GENERAL APPLICATION

Location Address: 1822 Dixiana Street Hollywood, FL 33020
 Lot(s): 11,12,13,14 E 30 Block(s): 7-11 B Subdivision: FRANK ADD TO
 Folio Number(s): 514210180050
 FH-2
 Zoning Classification: FH-2 Land Use Classification: Residential
 Existing Property Use: Residential Sq Ft/Number of Units: 13 units
 Is the request the result of a violation notice? Yes No If yes, attach a copy of violation
 Has this property been presented to the City before? If yes, check all that apply and provide
 File/Resolution/Ordinance No.: _____

Explanation of Request: Pre-TAC submittal for Apartment Development Project

SHEET
A-R.3

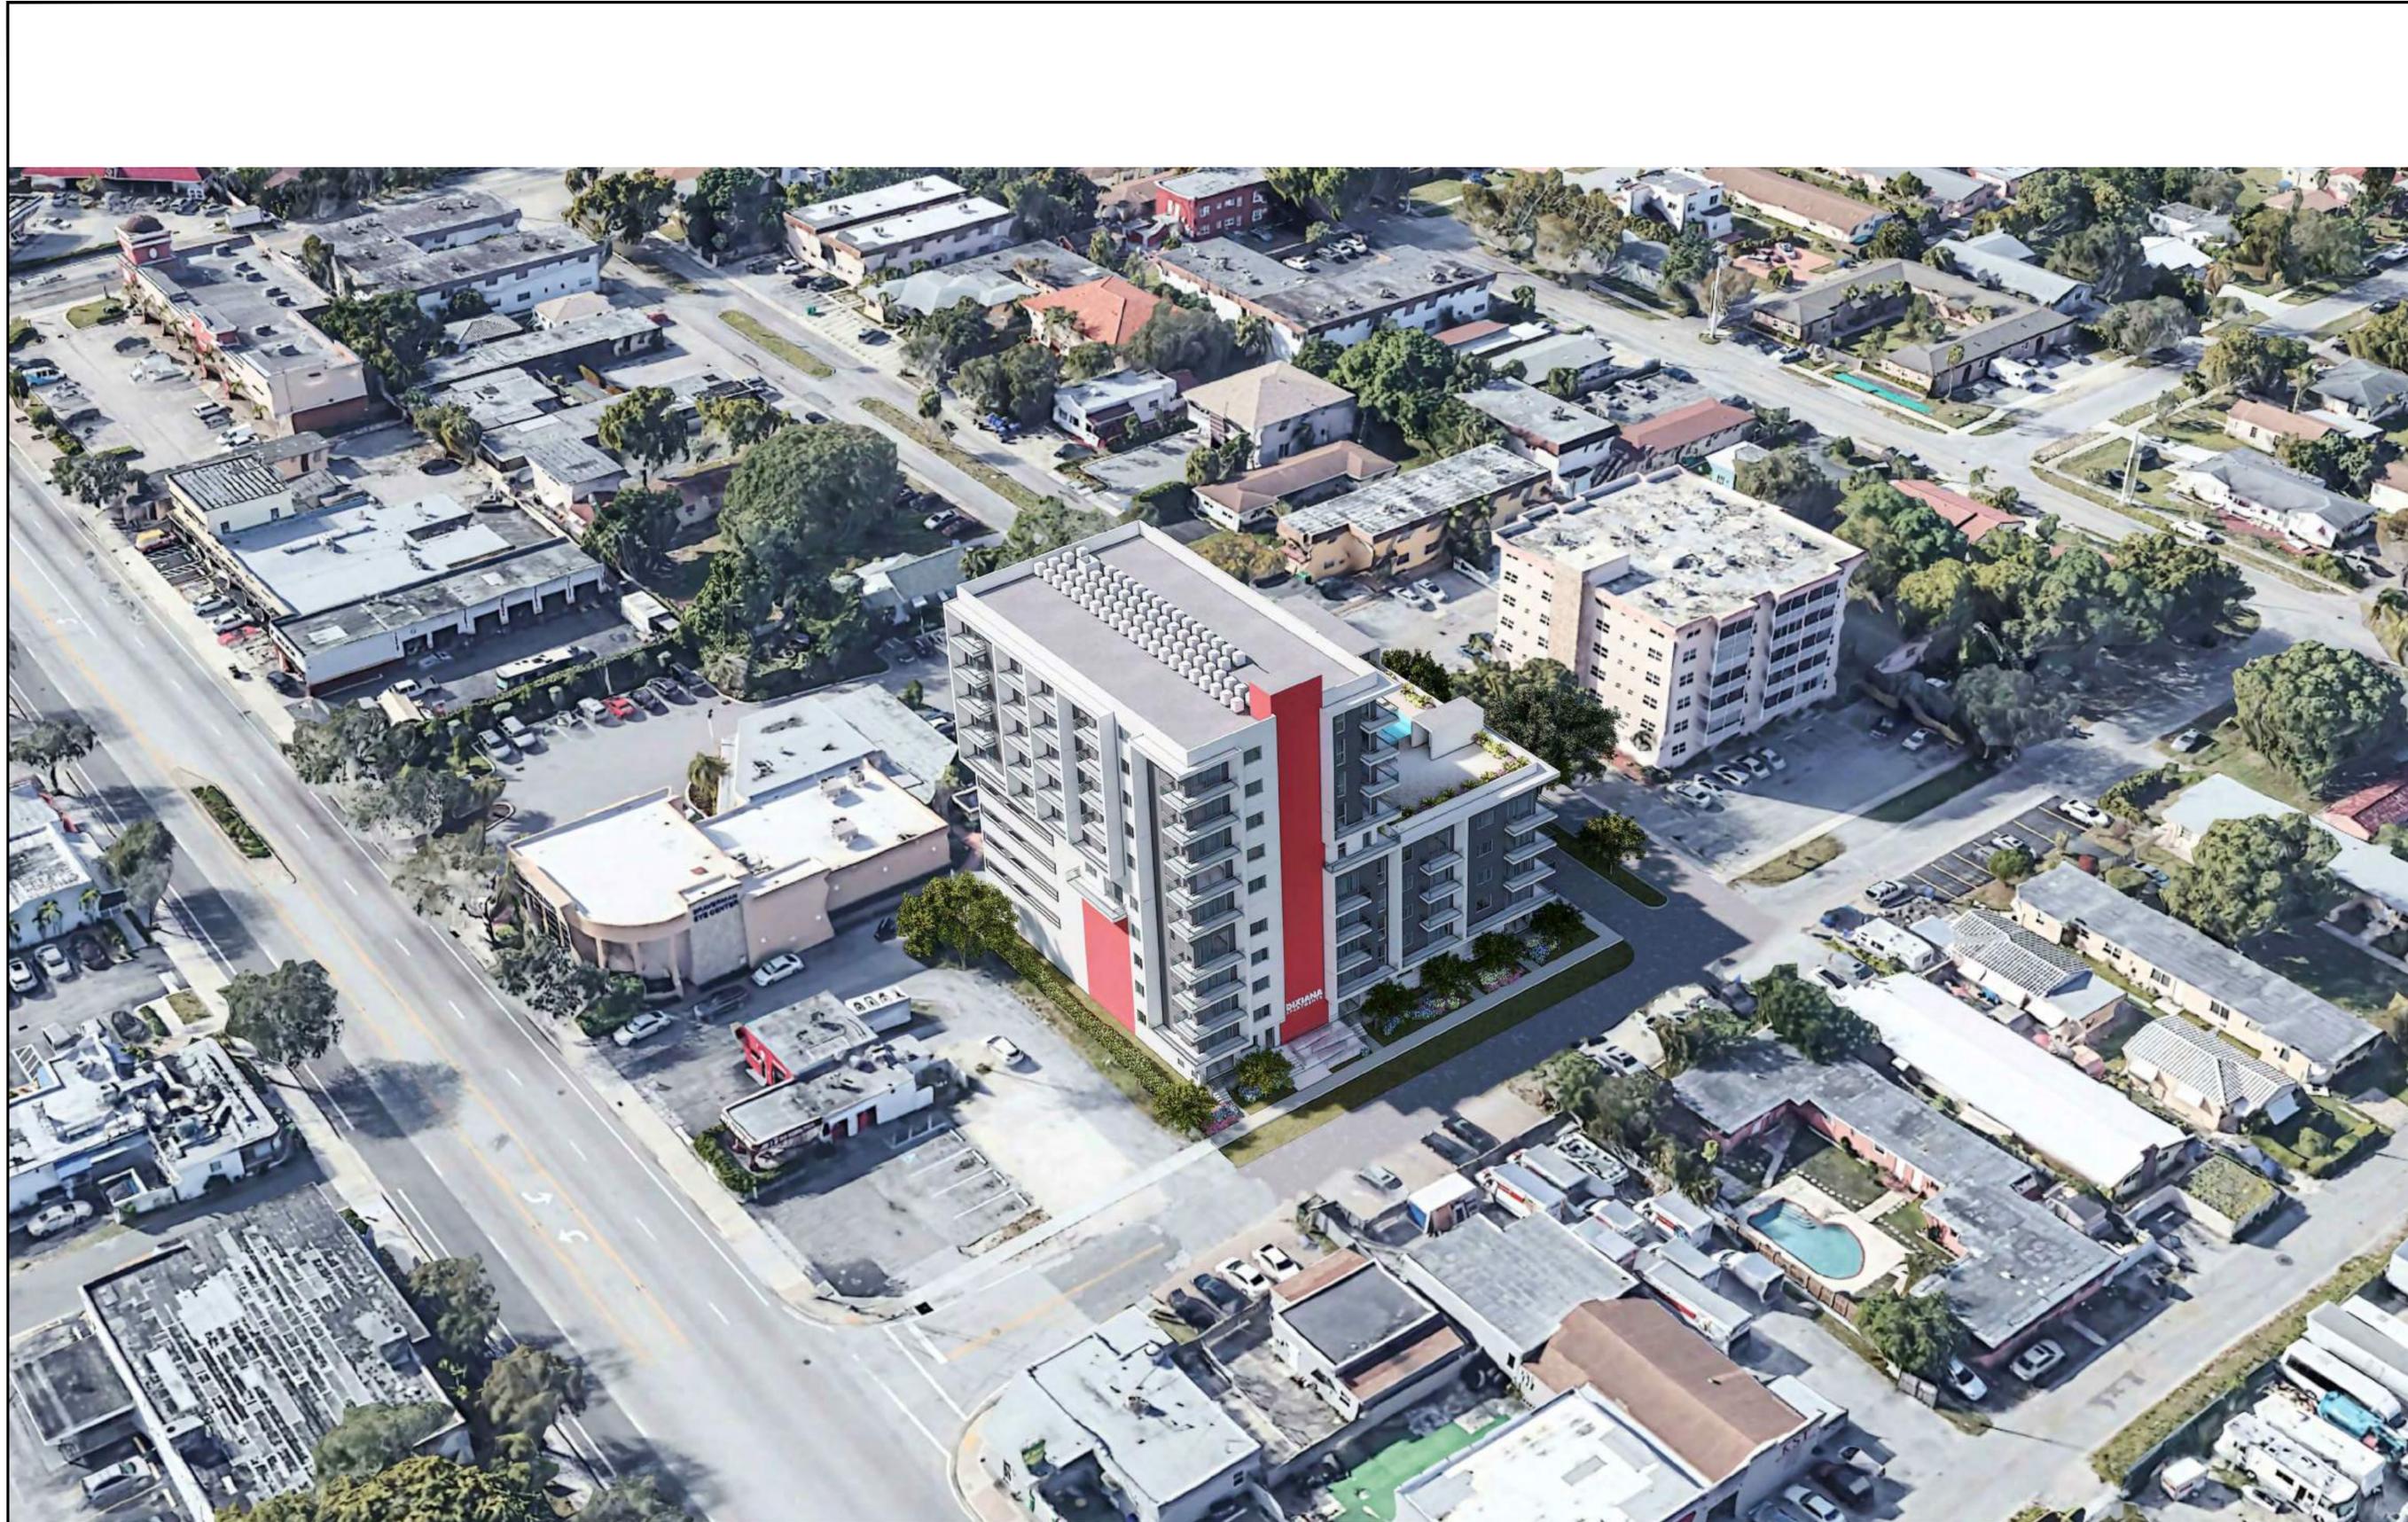
1. Provide a 3D rendering showing the west elevation. The main streets are Dixieana Street and 18th Court.

RESPONSE: Please see Sheets A-R.3 and A-R.2 including the West elevation.

A-1.0

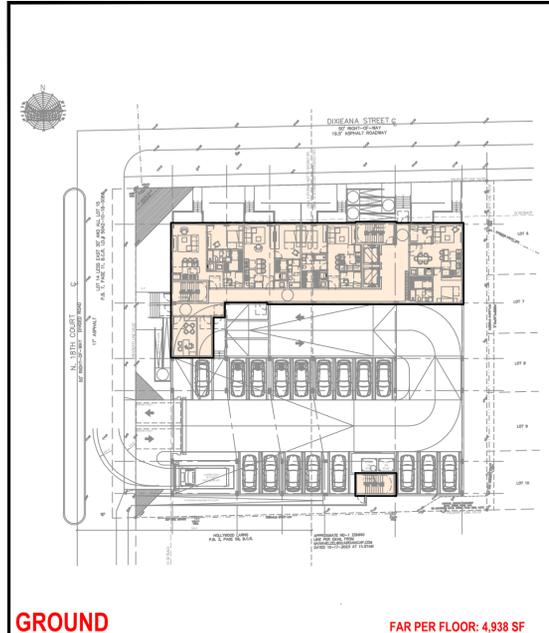
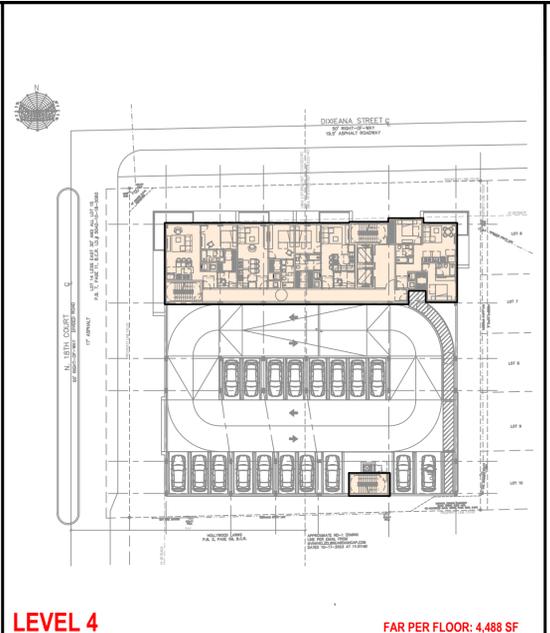
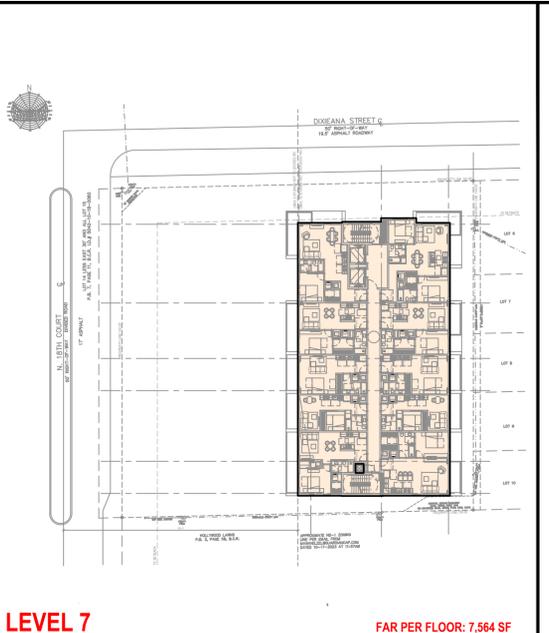
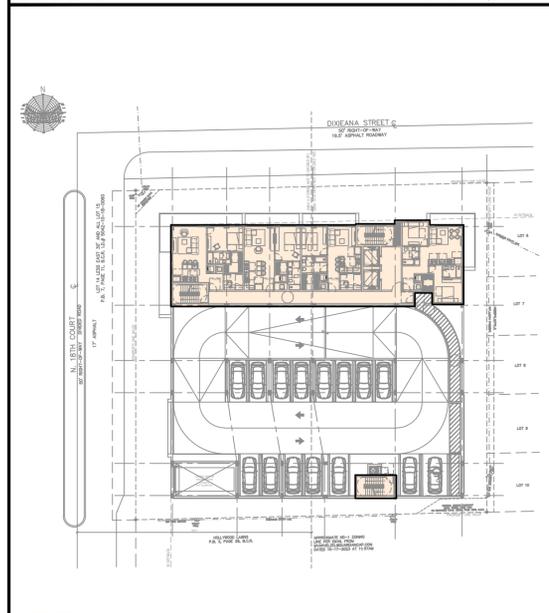
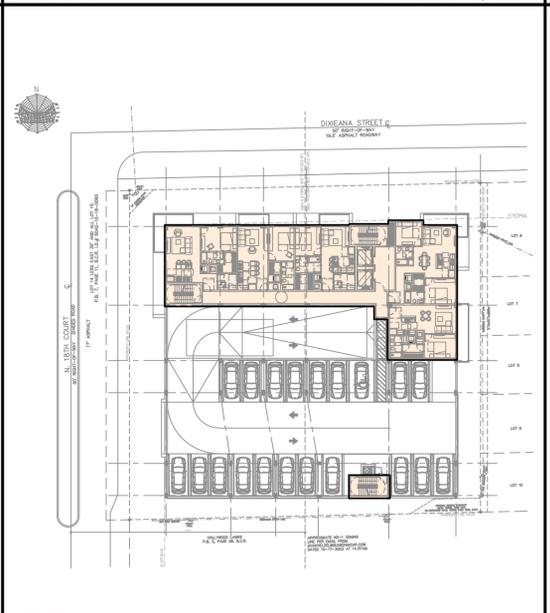
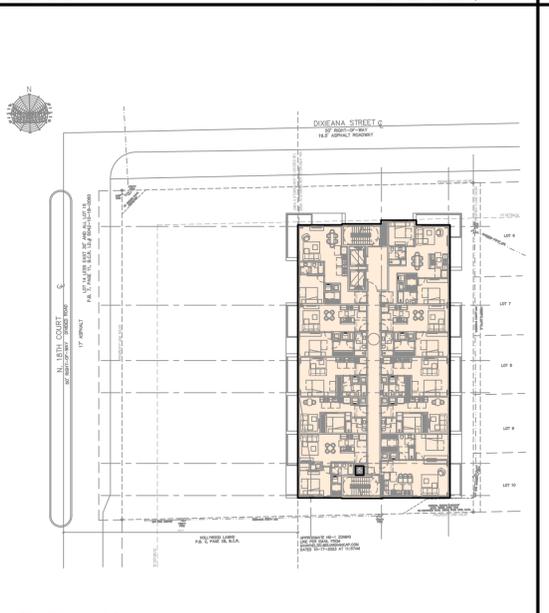
14. 40% of the walk up garden shall be pervious. Provide this calculation.

18. Provide a break down of the FAR per floor on a separate sheet.

RESPONSE: Calculation Provided on sheet A-1.1 which shows pervious area proposed at 60%.

RESPONSE: Provided in Sheet A-1.1

SHEET
A-2.1

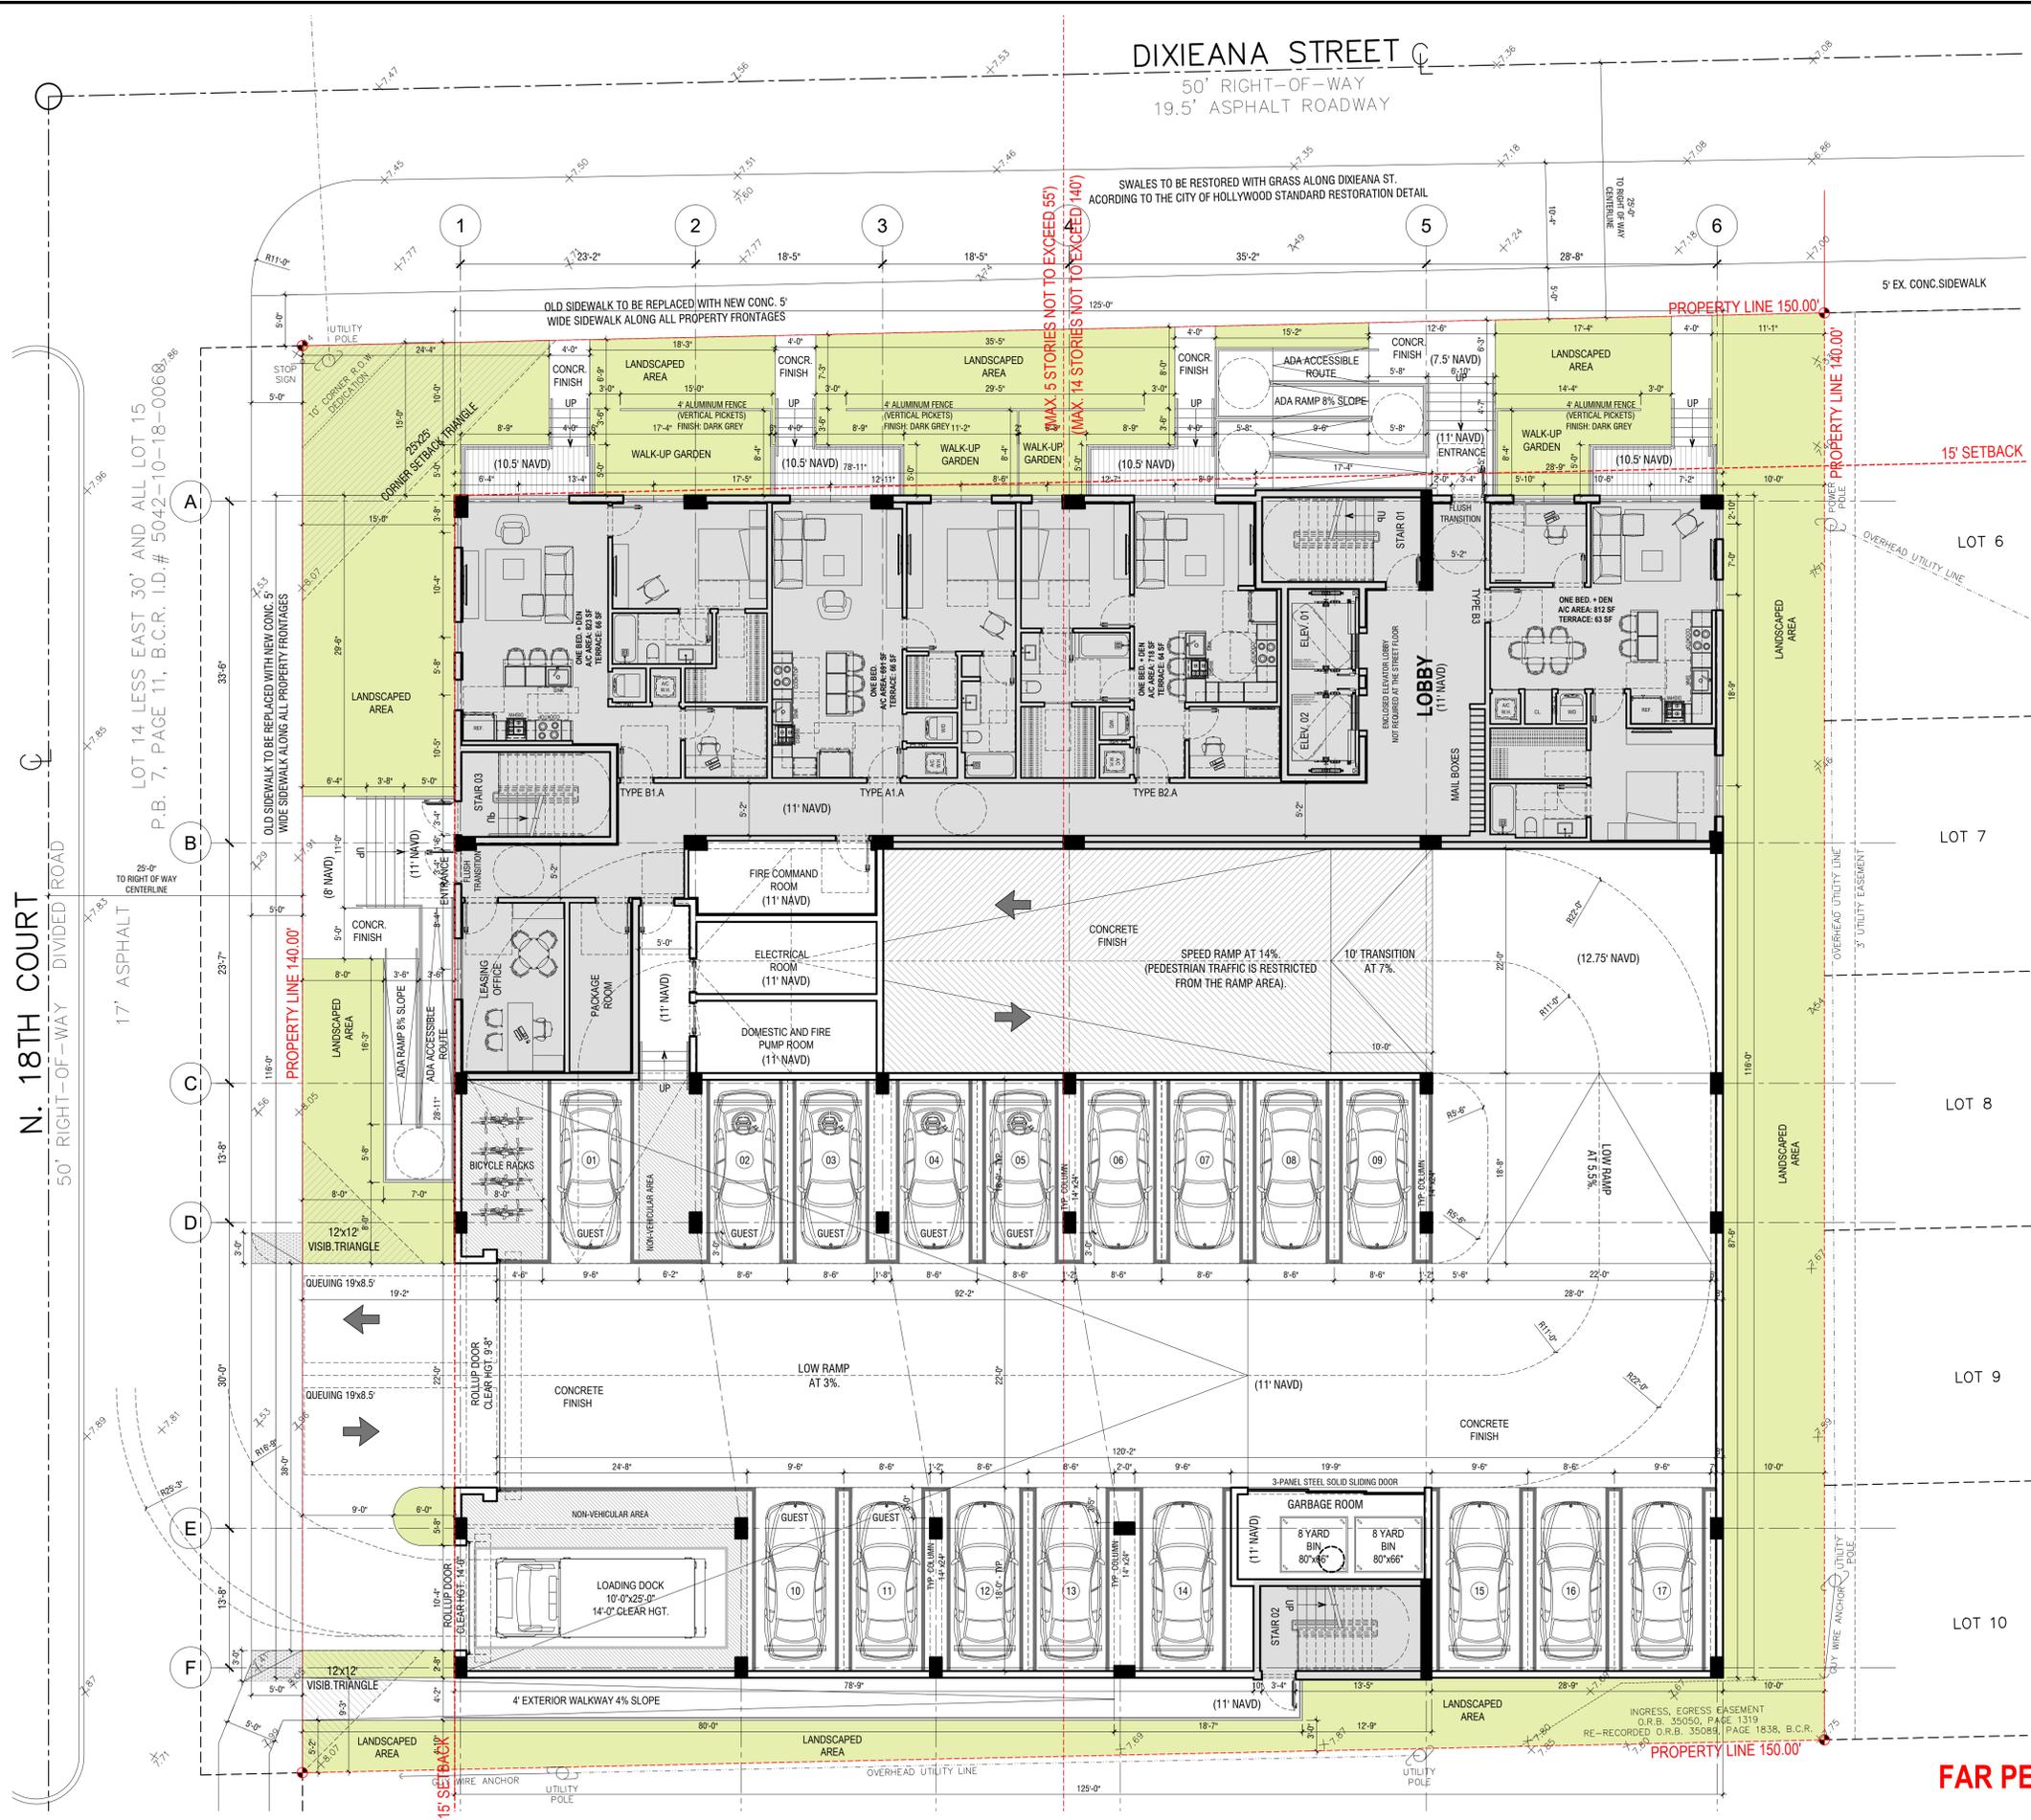
17. Please fully dimension or provide detail for the slab concrete walk paths along Dixieana Street, including the space in between and the size of the concrete slabs, etc.

25. Minimum queuing space required is 8.5'X19'. Please show on plan.

RESPONSE: Please see attached ground floor plan Sheet A-2.1 for dimensions

RESPONSE: Please see attached ground floor plan Sheet A-2.1 showing the queuing space being met.

EROSION & SEDIMENT CONTROL PLAN
SCALE: 1"=10'

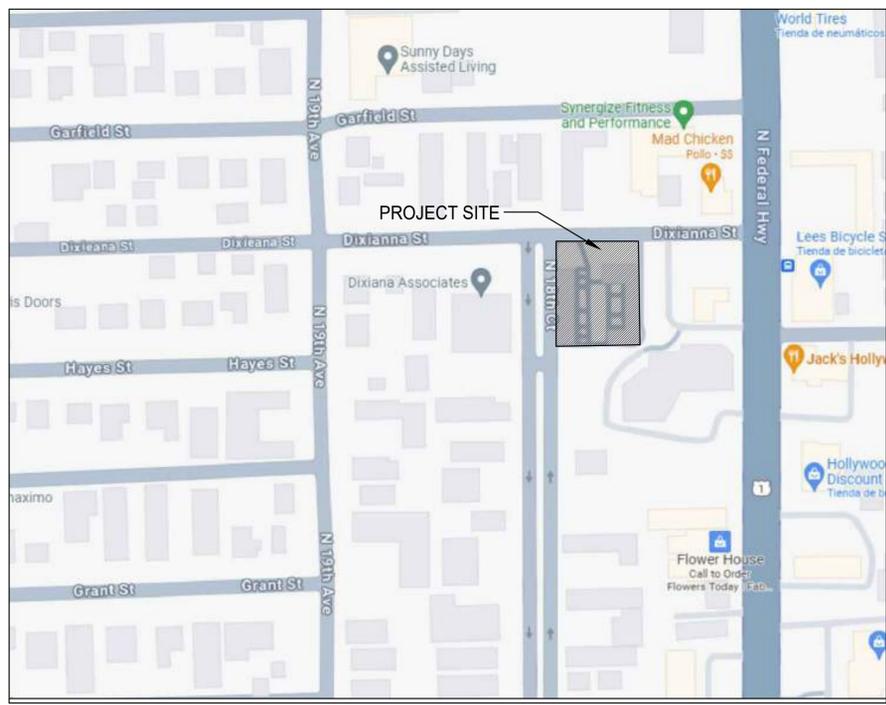
21. Submit Erosion Control Plan.
